Our Ref: S/4418/19/RM

Location: Land South Of Wheatsheaf Barn, Horseheath Road, Linton, Cambs

S/4418/19/RM – Croudace Homes Ltd - Land South of Wheatsheaf Barn, Horseheath Road, Linton - Approval of matters reserved for access, appearance, landscaping, layout and scale following outline planning permission S/2553/16/OL for the erection of 42 dwellings including the provision of 0.45ha for allotments – Decision Required.

LPC Comments 21/1/20 on S/4418/19/RM

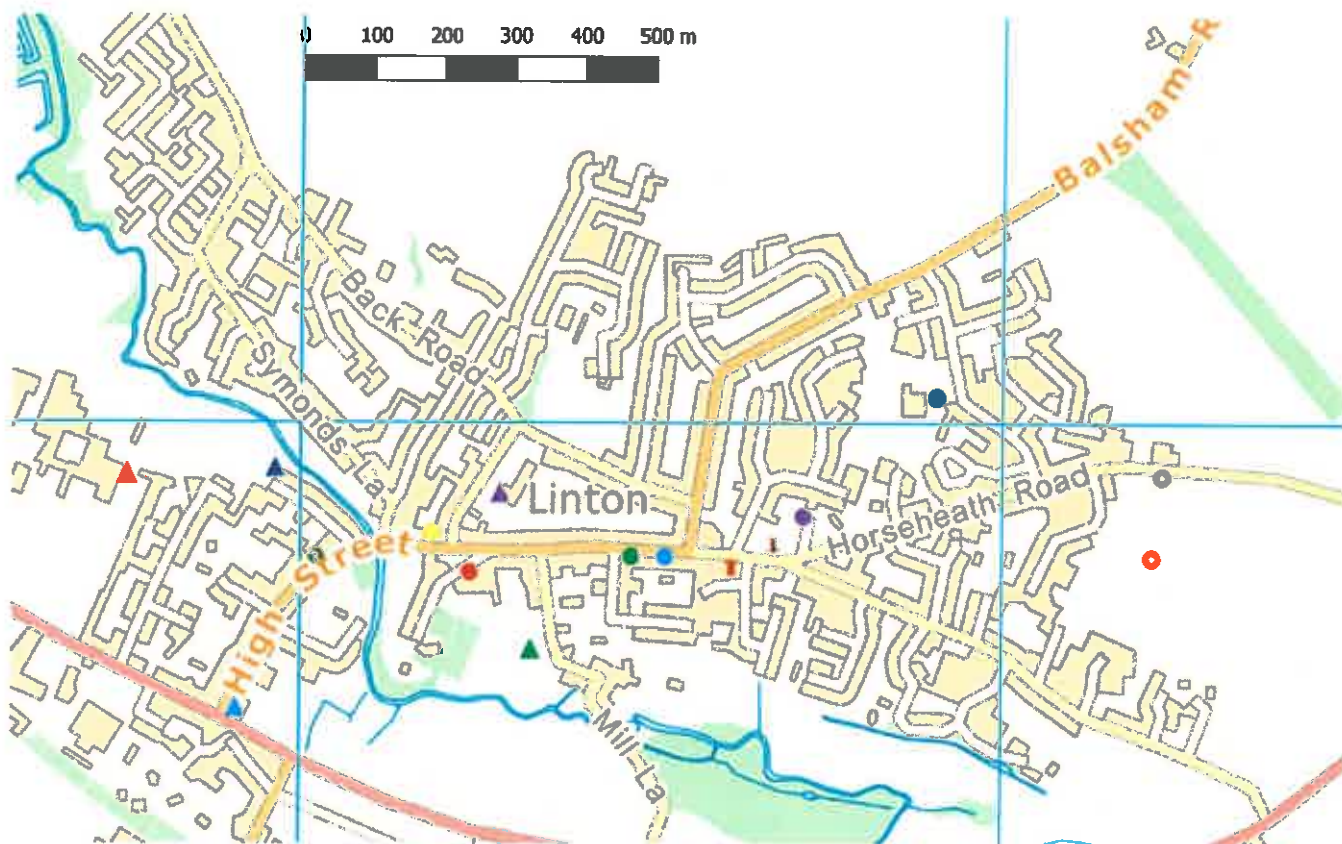
Appendix 5 shows another layout, this time to relocate the LEAP, but it is more cramped and has back to back distances between houses that are worse than before. It also shows the scheme is dependent on a substantial number of deep plan houses and areas of water storage / SUDs along the boundaries above existing houses. It also does not include for the space taken up by the proposed floodwater bunding, and shows the area allocated to allotments has further decreased.

It demonstrates further incremental cramping of the site and further incremental burdens of maintenance which have not been adequately assessed, managed and mitigated.
